Access Compliance Report

Public Rights-of-Way

(Curb Ramps)

Intersection ID: 42359	Main Street: HERON_GLEN_DR	Cross Street: WRENS_NEST_LN	Location: S
ADA ID: 47C2DF4066FE	Ramp Type: PerpDiag	Initial Pass/Fail: Pass	Overall Compliance: No
Codes/Mitigation Info/Possible Solution		Field Measurements/Component Compliance	
Severity Score: 10.25

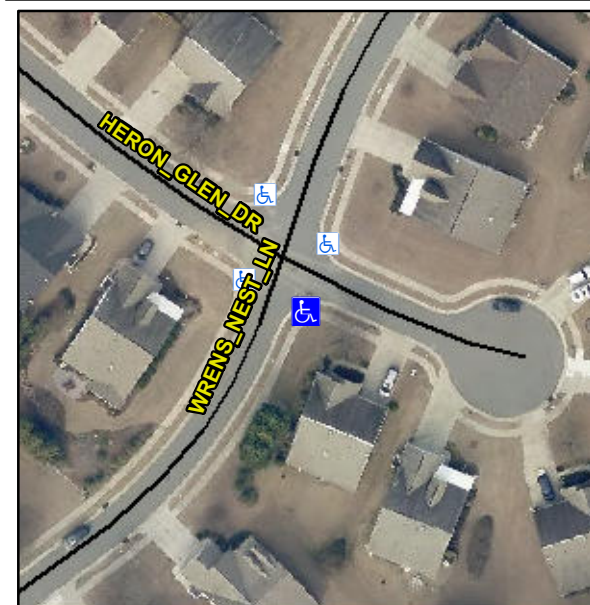
Not Found, R304.5.3, R304.2.2-Perp, R304.3.2-Para, R305

Compliance	Description	Data	Compliance	Description	Data
N/A	Ramp Length (in)	46.0	Yes	Ramp Slope (%)	6.1
Yes	Ramp Width (in)	66.0	No	Ramp XSlope (%)	2.7
N/A	Flare Type LT	Sloped	N/A	Flare Type RT	N/A
N/A	Flare Slope LT (%)	0.9	N/A	Flare Slope RT (%)	9.0
N/A	Flare Traversable LT?	No	N/A	Flare Traversable RT?	No
Yes	Landing Length (in)	48.0	No	DWS Provided?	No
Yes	Landing Width (in)	60.0	N/A	DWS Contrast?	No
No	Landing Slope (%)	3.8	N/A	DWS Length (in)	N/A
No	Landing X Slope (%)	3.6	N/A	DWS Full Width?	No
N/A	Landing Curb? (Y/N)	No	N/A	DWS Offset (in)	N/A
N/A	Shared Landing?	No			
Yes	Gutter Ponding?	No	Yes	Gutter Slope (%)	4.1
Yes	Gutter Lip Ht (in)	0.0	No	Gutter X Slope (%)	2.3
N/A	Painted X Walk1?	No	N/A	Painted X Walk2?	No
	X Walk 1 Direction	To NW		X Walk 2 Direction	To NE
N/A	X Walk 1 Width (in)	N/A	N/A	X Walk 2 Width (in)	N/A
	X Walk 1 Slope (%)	0.8		X Walk 2 Slope (%)	1.9
	X Walk 1 X Slope (%)	4.1		X Walk 2 X Slope (%)	0.2

Remove & Replace Curb Ramp With Two New Directional Ramps or Equivalent. Remove & Replace Gutter.
